PROJECT TITLE: Little Anita's Restaurant
Remodeling & Additions ZONE ATLAS/DRN. FILE #: J-21/D24

Revised Drainage Plan showing
drainage outfall across Lot 2
And agreement for same.

RE: GRADING/PAVING PLAN FOR LITTLE ANITA'S RESTAURANT
(J-21/D24) REVISION DATED JUNE 1, 1988

SUMMARY OF REVISIONS

GRADING AND DRAINAGE PLAN 1" = 20'

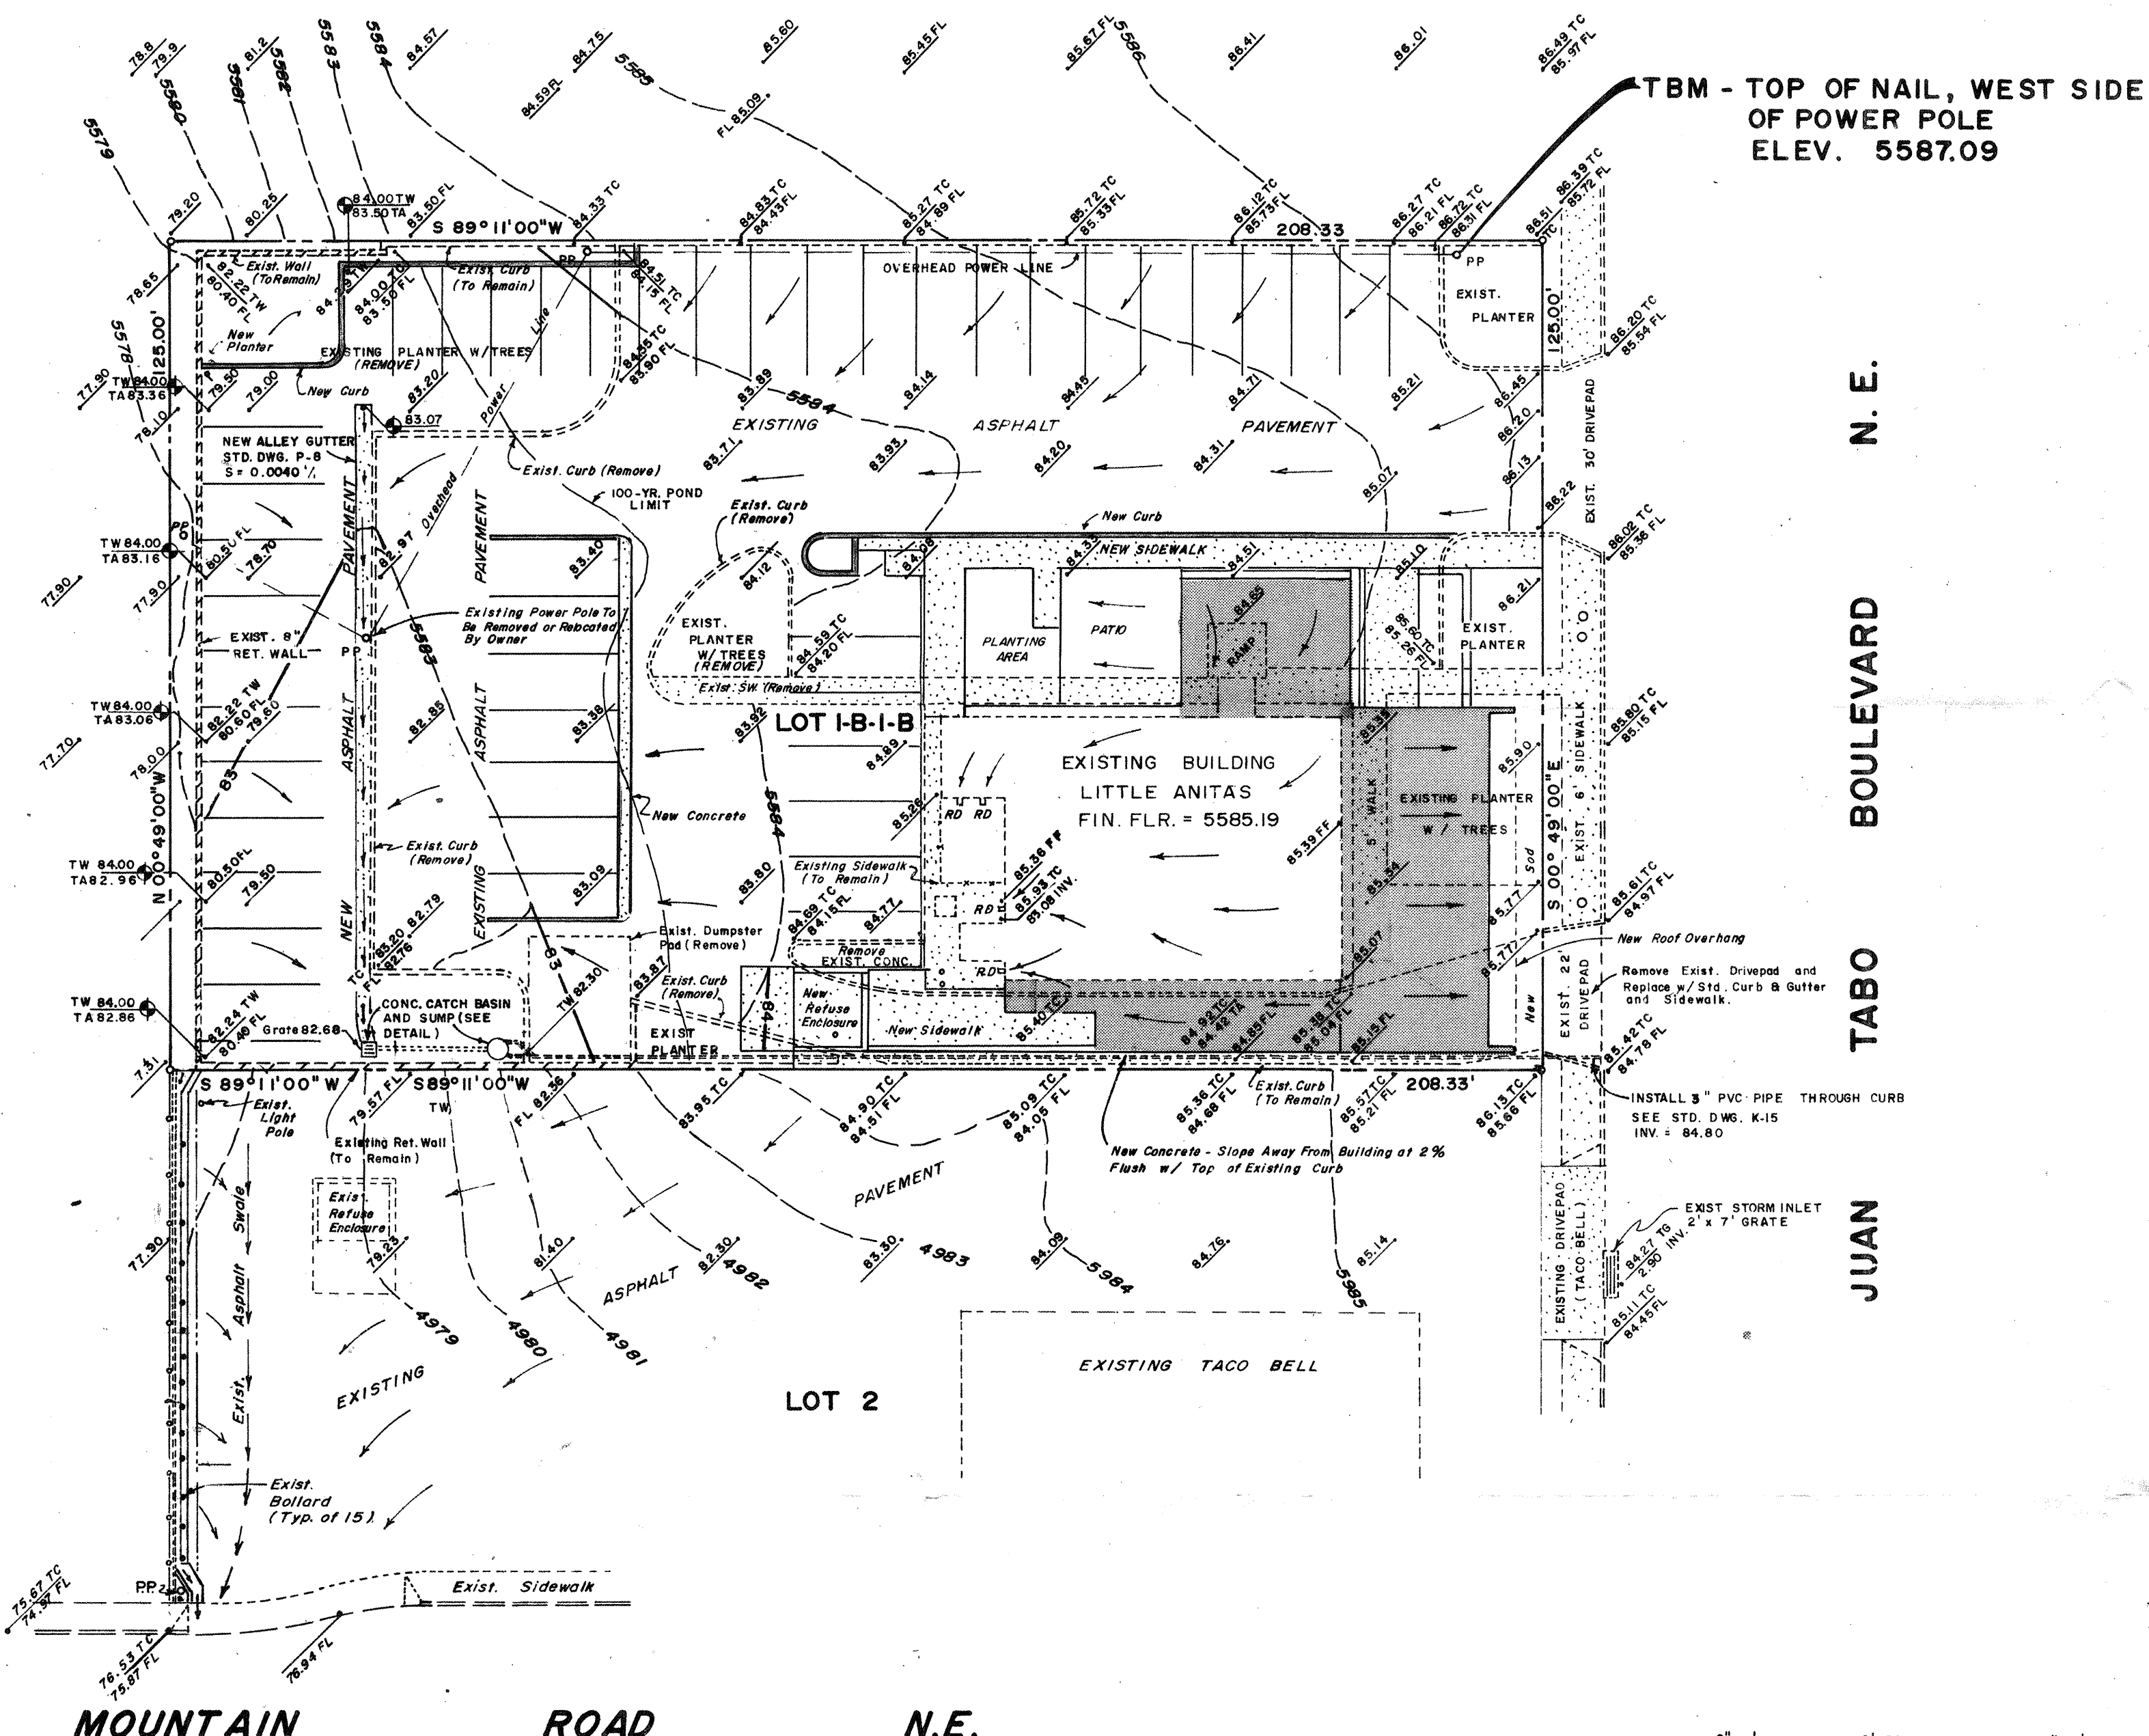
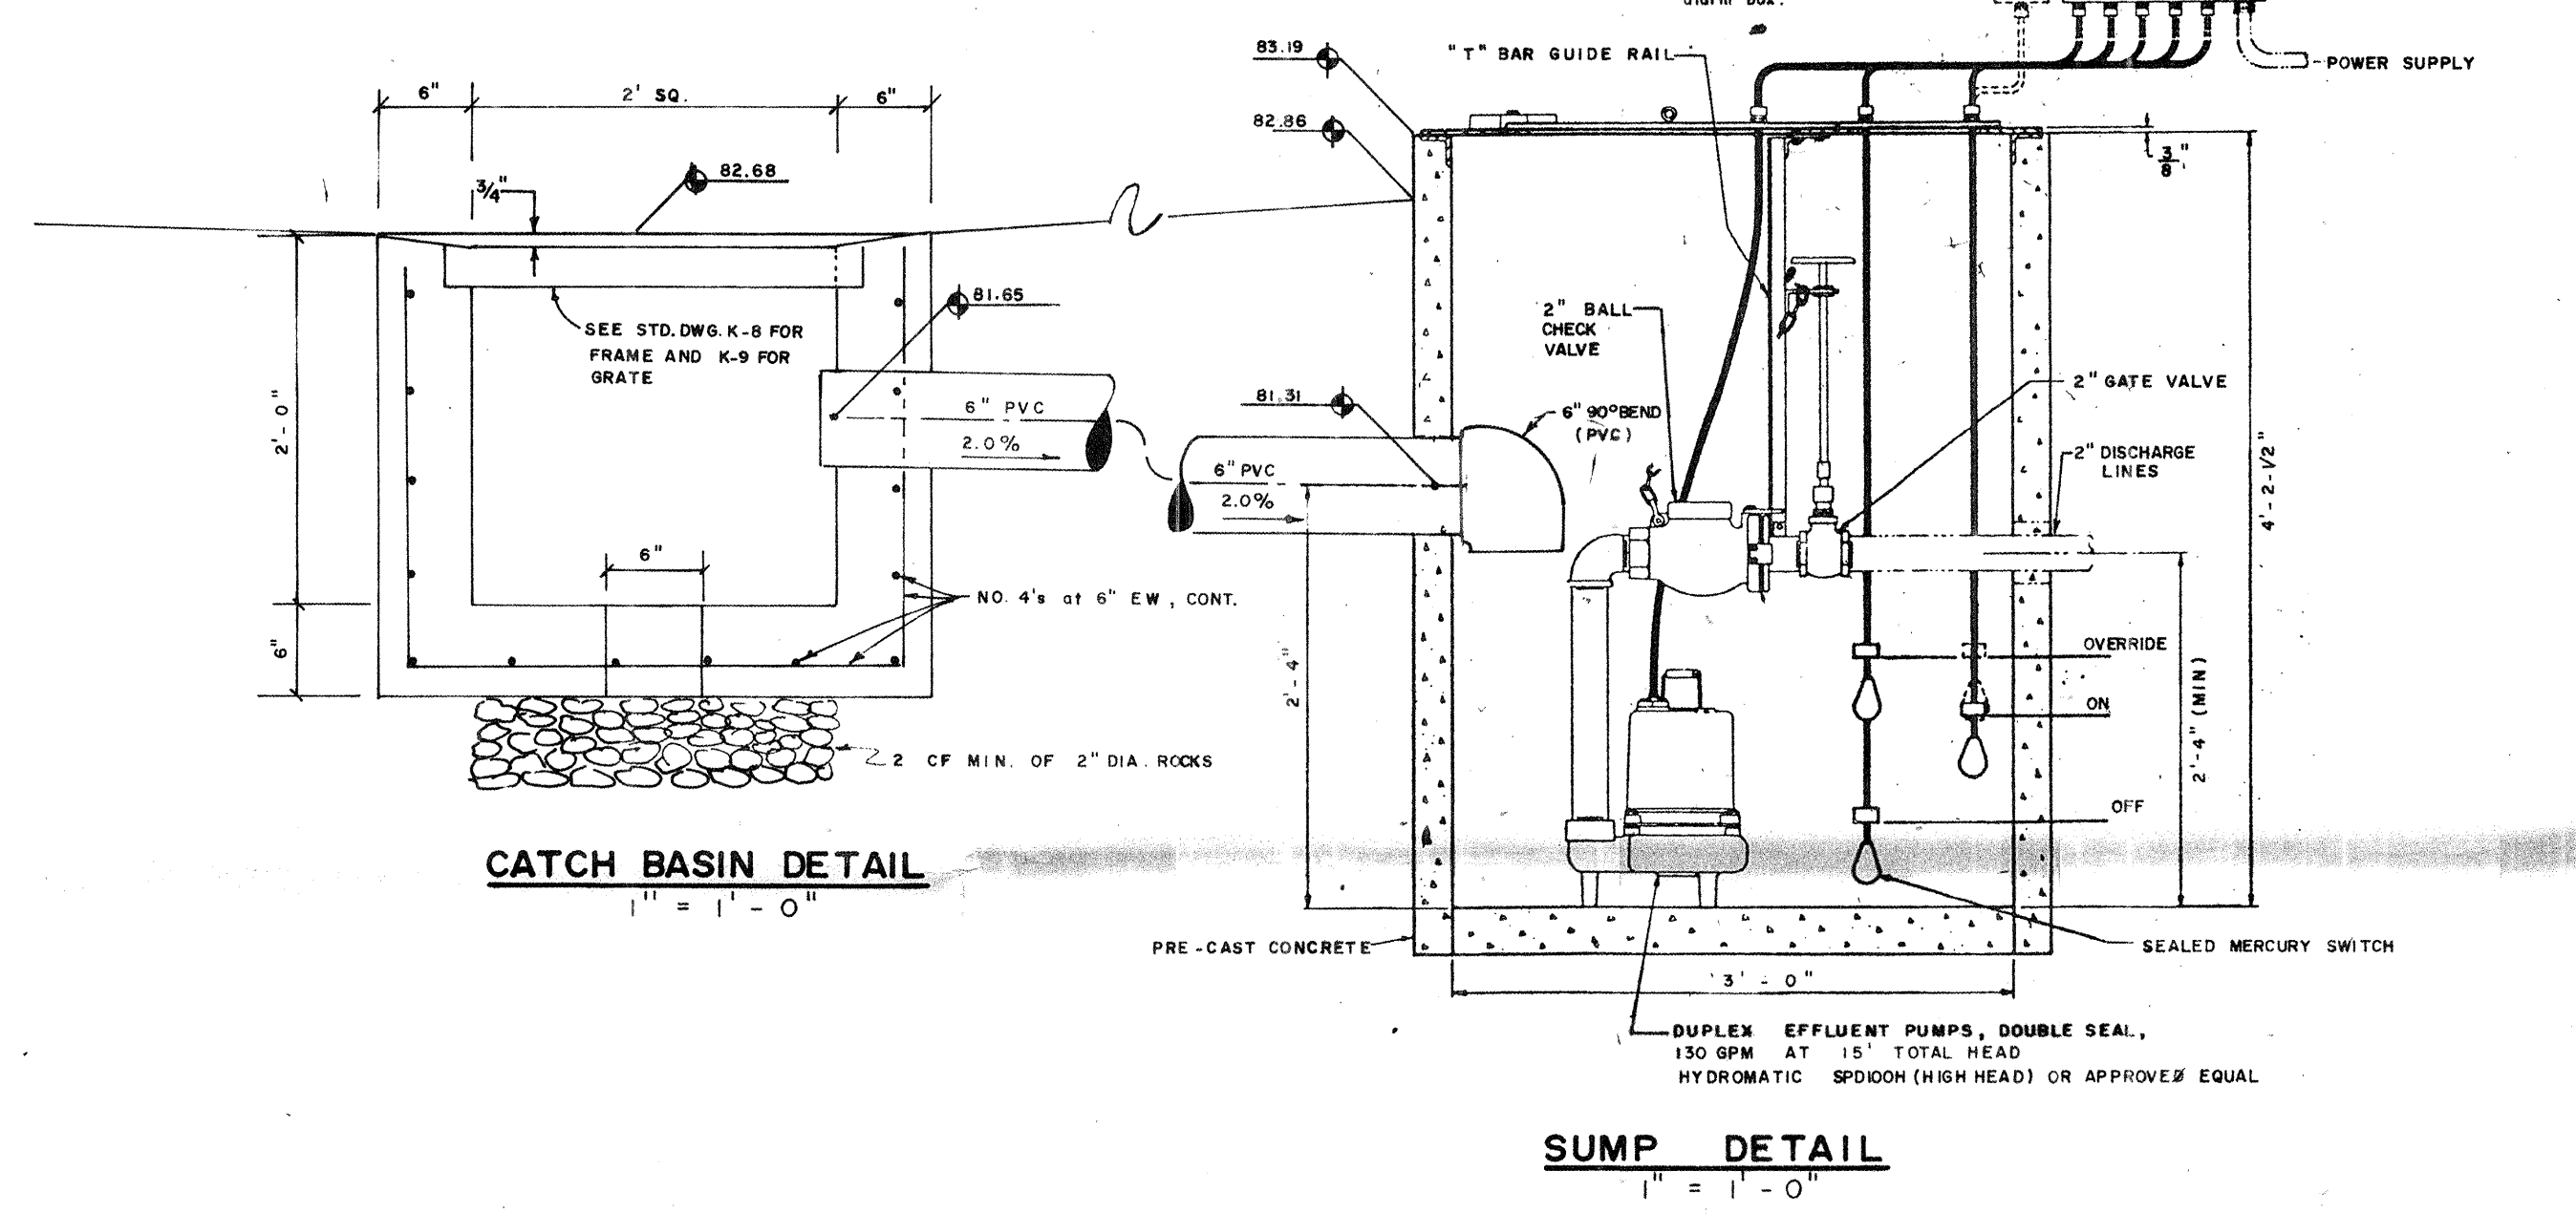
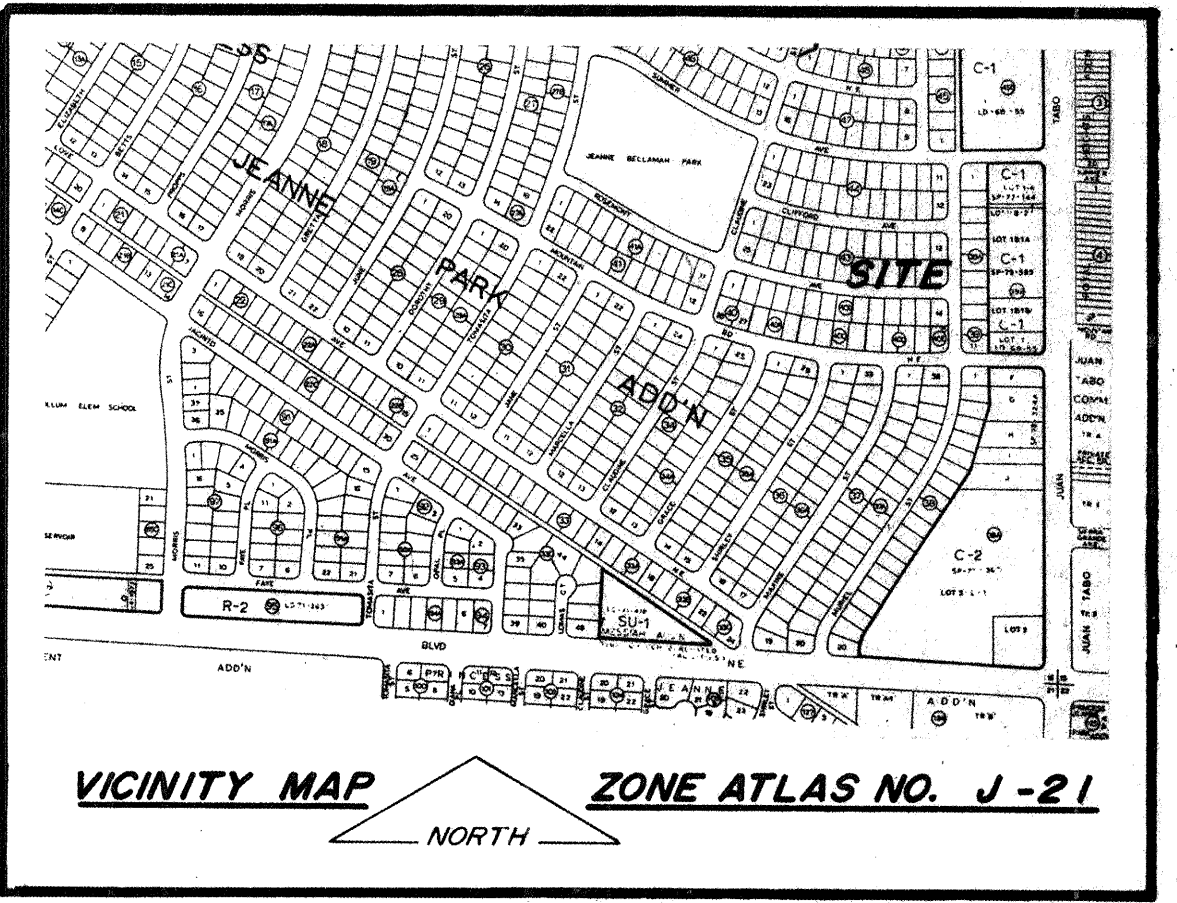
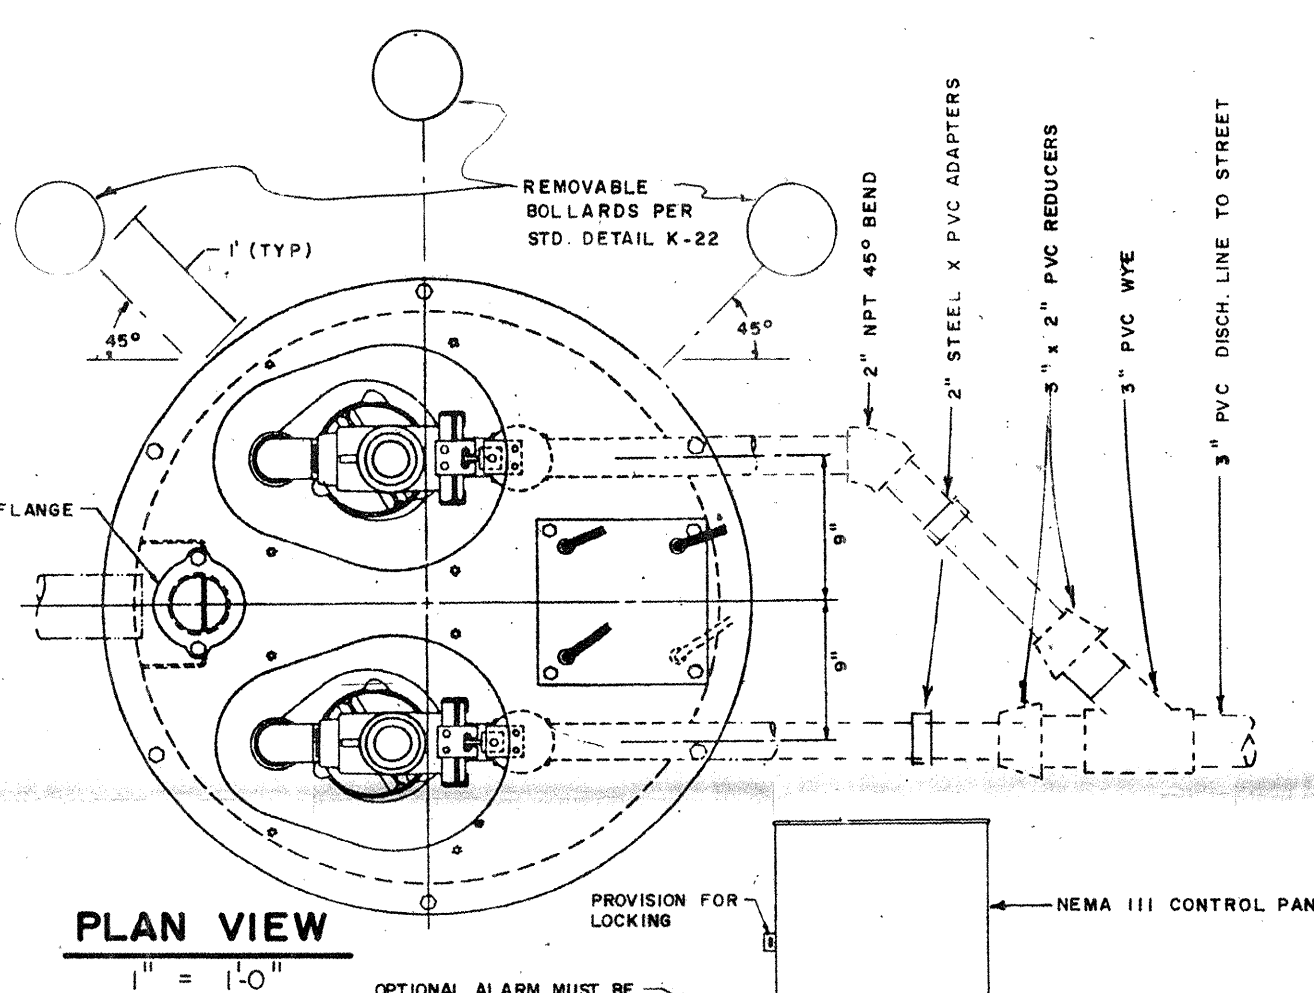
1. The adjacent property owner to the south has not granted the necessary drainage easement across his property to Mountain Road. Therefore, a sump pump system is required.

2. The grading of the westerly end of the lot had to be revised to make the parking lot as flat as possible to contain as much volume as could be reasonably contained at a minimum depth. An alley gutter was added to along the west edge of the existing pavement, the grade of which is now approximately 0.4% . Without the alley gutter, drainage of the asphalt would be very poor since placement of asphalt cannot be controlled to such a flat grade.

3. The volume of parking lot ponding was arbitrarily calculated by cross-sections for a depth of 1.0' above the catch basin grate. This volume was 3918 CF, the water surface being approximately 7950'. An additional depth of $1\frac{1}{4}$ inches or 0.1' give the required 100-year flood volume in the event that the pumps did not work. The volume was recalculated for a HWL of 83.5'. This ponds 10 inches at the deepest point and ponds a volume of 2721 CF. This is approximately equivalent to the maximum ponding that would occur with both pumps operating.

4. A duplex pump system was selected which will discharge approximately 130 GPM per each of the two pumps, or 260 GPM when both pumps are operating. The total volumes of required storage and pumping were computed by the triangular hydrograph method. The pumping system selected is the low horsepower pump range. A larger system would result in an unrealistic increase in cost.

5. The catch basin will also serve as a grit chamber to prevent gravel from entering the sump.
